## Quality Assurance of Chapter 11: Requirements on Upper Shelf Energy

This report documents the results of the quality assurance (QA) task for Chapter 11 of the draft technical basis NUREG for the risk-informed Appendix G project. Chapter 11 discusses the derivation of updated minimum upper shelf energy (USE) requirements for reactor vessels. The quality assurance effort for this chapter involved three specific subtasks: (1) confirming the validity of stress intensity factor equations used in Regulatory Guide (RG) 1.161, (2) verifying calculations of minimum USE based upon the RG 1.161 methodology, (2) verifying Fracture Analysis of Vessels-Oak Ridge (FAVOR) runs used to calculate minimum USE.

Figure 1: Comparison of the RG 1.161 equation for  $K_p$  with three methods.

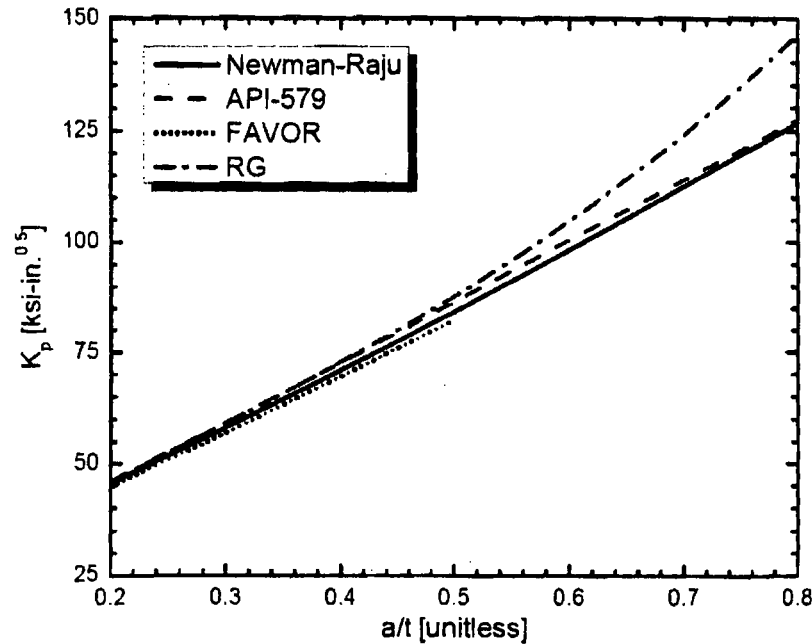
The Newman-Raju method shown in Figure 1 is the original work upon which Equation 1 is based. Details for that method can be found in reference z. Figure 1 shows that there is reasonable agreement of the RG 1.161 equation for  $K_I$  due to pressure with the other methods, even with the boiling water reactor vessel geometry (note: Equation 1 ceases to be valid past  $a/t = 0.5$ ).

1. The  $K_p$  and  $K_{th}$  equations (Equations 1 and 5, respectively), while originally developed for only PWR vessel geometry, were verified for use for BWR vessel geometry.

Figure 5: Comparison of the RG 1.161 thermal SIF calculation with two other methods.

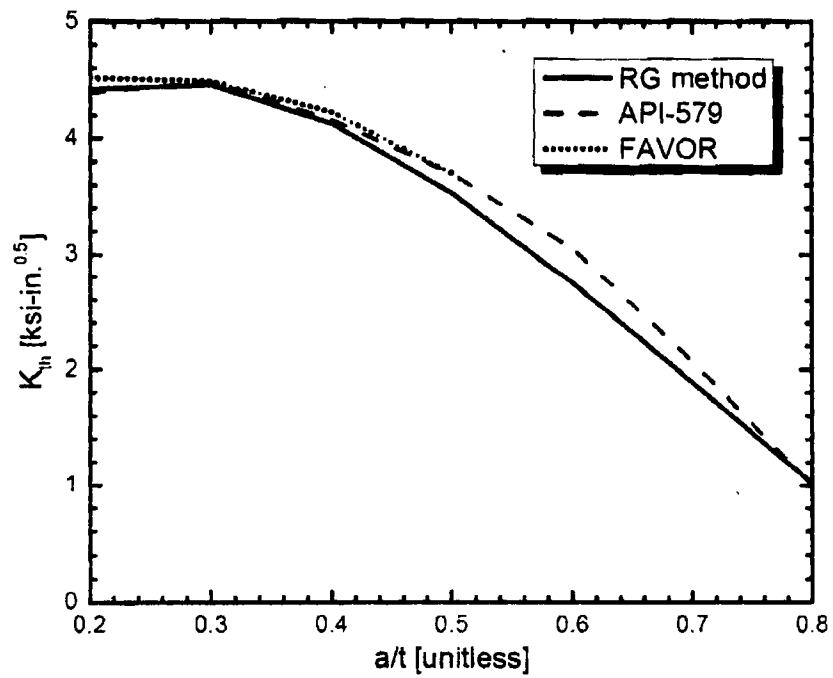
Figure 5 shows that the RG 1.161 equation agrees reasonably with the FAVOR and API-579 methods.

Figure 6: Required USE calculated according to RG 1.161 for (a) TB work and (b) QA work.

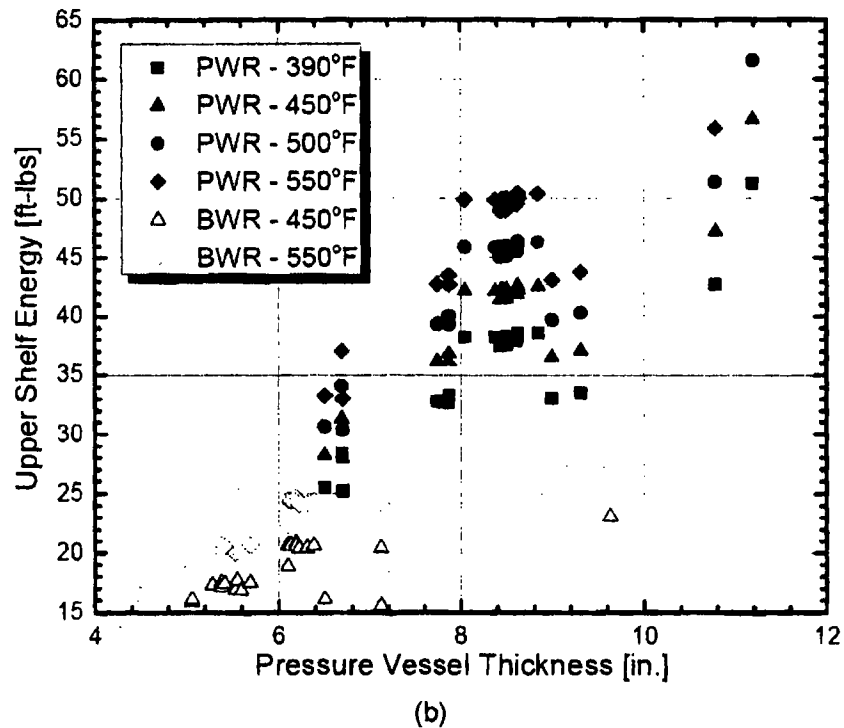
The interviews revealed one issue of concern for the RG 1.161 calculations: the crack stability criterion (Equation 2) was not employed in the TB work. As a matter of technical rigor, the crack stability criterion should always be included in the calculations, since the safety factor for that criterion is higher than that for the non-initiation criterion (Equation 1). The results of these calculations from the TB work and QA work are compared in Figure 6 (a) and (b), respectively.

The results from the QA work (which accounted for crack stability) compare well with the results from the TB work, demonstrating the fact that the non-initiation criterion plays a dominant role in determining required USE. The issue raised by the QA work, therefore, has little effect on the results of this calculation.

2. While the TB work incorrectly neglected the crack stability criterion for the RG 1.161 calculations, modifying the analysis to account for crack stability does not change the results of the analysis.

Figure 3: Comparison of required USE obtained from the RG 1.161 and FAVOR methods for (a) the TB work and (b) the QA work.

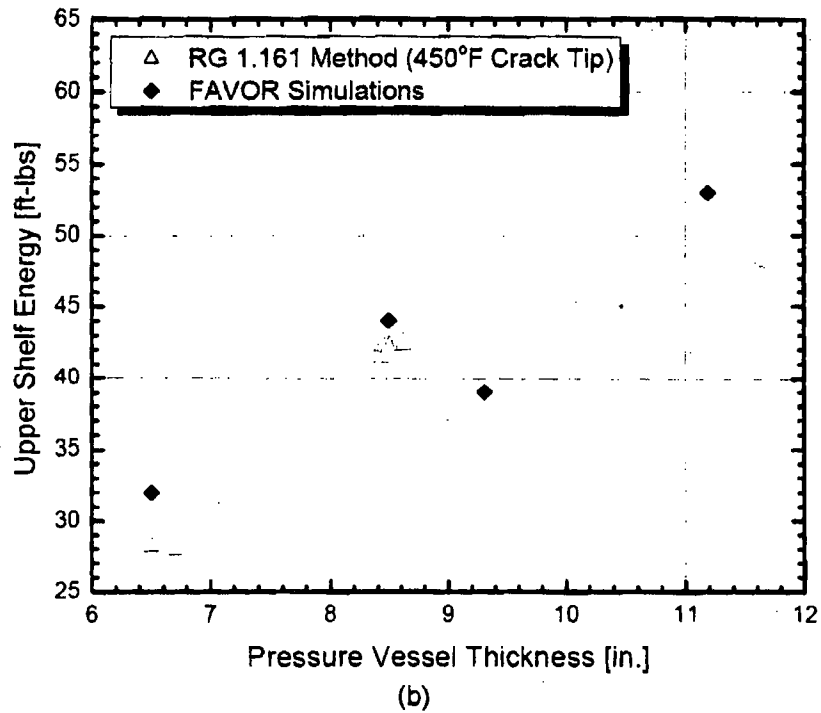
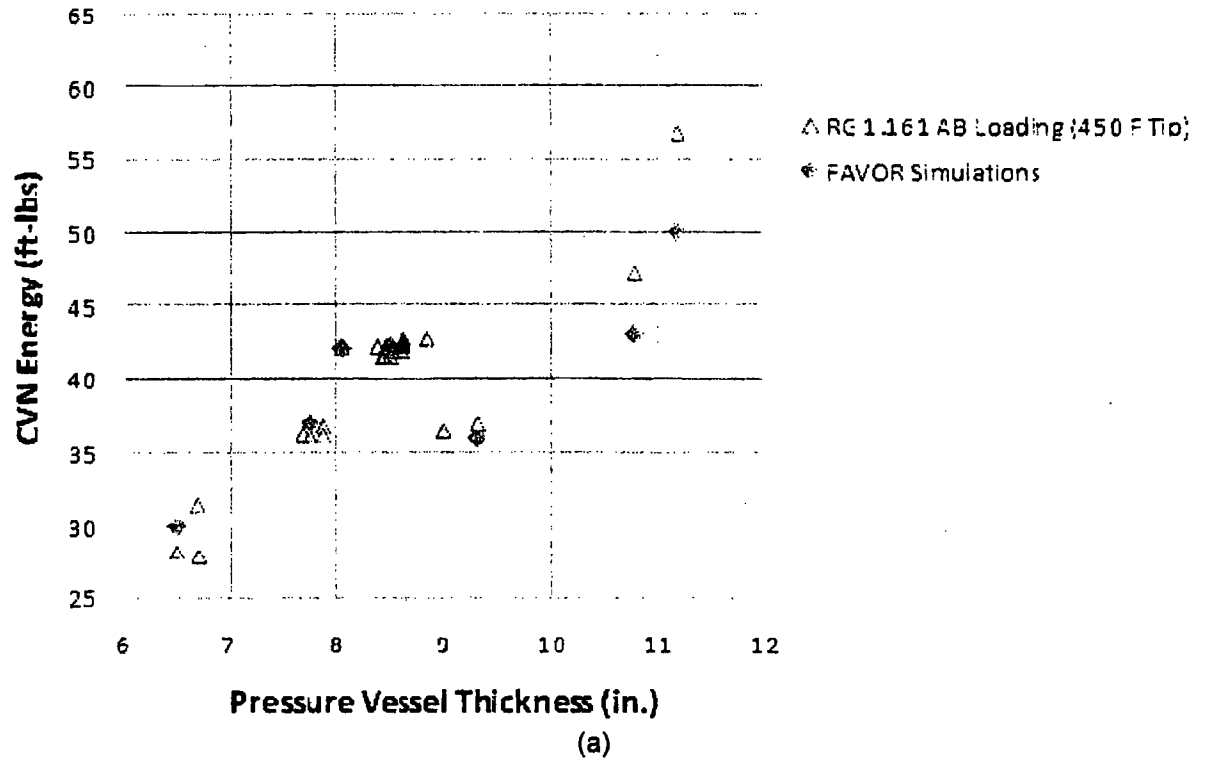
The QA calculations included a factor of 1.09 in the applied J calculation, in order to account for the small scale yielding correction. For the purposes of calculating required USE, this procedure is not recommended. For the purposes of the QA work, however, it provides a method to assess the error introduced by neglecting the small scale yielding correction. A comparison of Figures 3 (a) and (b) shows that the required USE is increased by roughly 3 ft-lbs when accounting for small scale yielding. The main conclusion of the TB regarding this work (i.e., that 450°F is the correct temperature input to J<sub>R</sub> model) remains valid, since the results of the FAVOR simulations match closely with the results of the RG 1.161 calculation.

3. The proposed procedure to calculate J from FAVOR results neglects the small-scale yielding correction (Equation 7), which can increase the calculated J by 9%.

4. After adjusting the calculated J results by a factor of 1.09 to account for small scale yielding, the results still confirm the original conclusion from the draft TB: 450°F is an appropriate crack tip temperature to use for the RG 1.161 calculations.

Figure 4: Proposed USE limits plotted with results from RG 1.161 calculations: (a) TB work, (b) QA work.

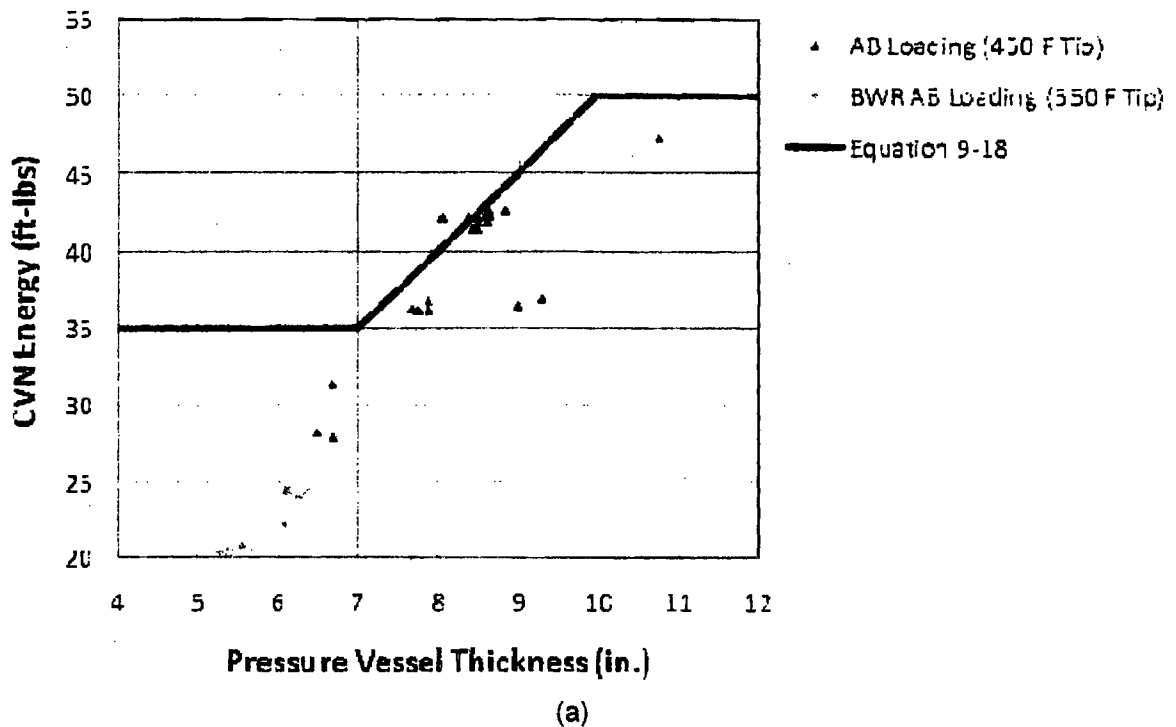
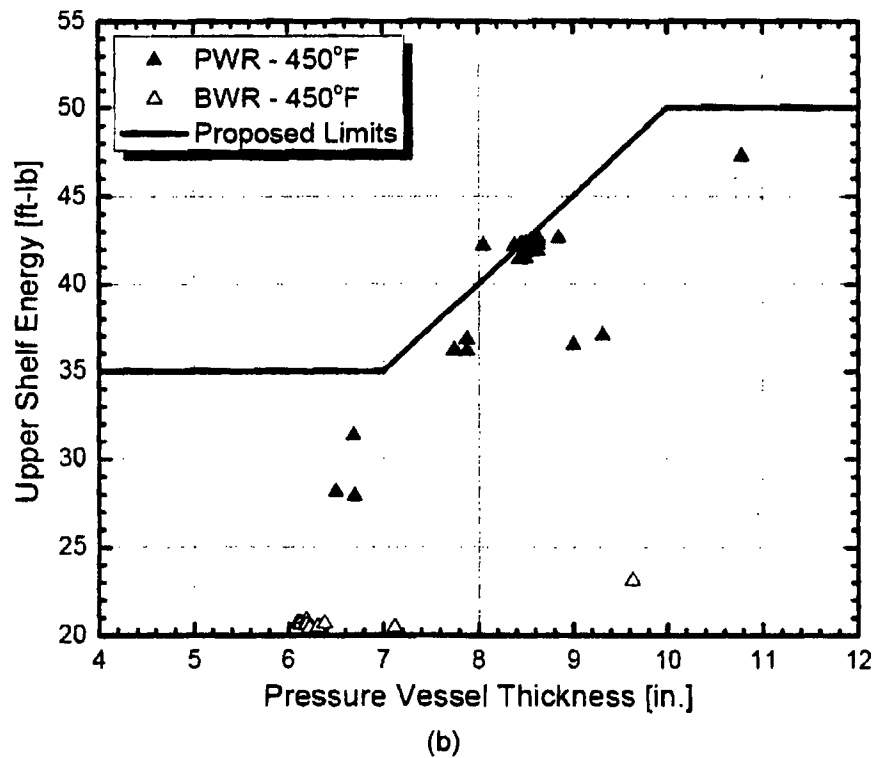
Figures 4(a) and (b) show reasonable agreement.

Figure 5: Figure reference in draft TB to demonstrate a situation where the crack stability criterion is violated.

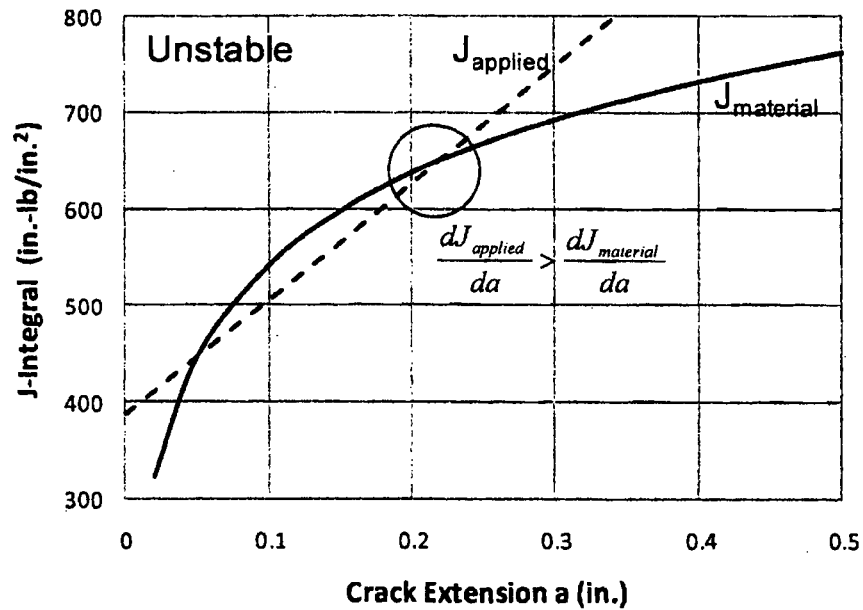
The draft TB for the minimum USE shows Figure 5 to demonstrate a situation where the crack stability criterion is not met.

In fact, Figure 5 illustrates a situation that meets the crack stability criterion, since there is a portion of the driving force curve (i.e., applied  $J$ ) that lies below the resistance curve (i.e.,  $J_{\text{material}}$  in the figure, or  $J_R$ ). While the slope of  $J$  is indeed greater than the slope of  $J_R$  at the point circled, the correct intersection point to perform this evaluation is the one located at lower crack extension. This concept can be confirmed by considering a figure from a fracture mechanics text (Figure 6).

5. Figure 5 should not be included in the TB to demonstrate instability, since it actually demonstrates stability.
6. The proposed thickness-dependent USE limit was independently verified by the QA work.
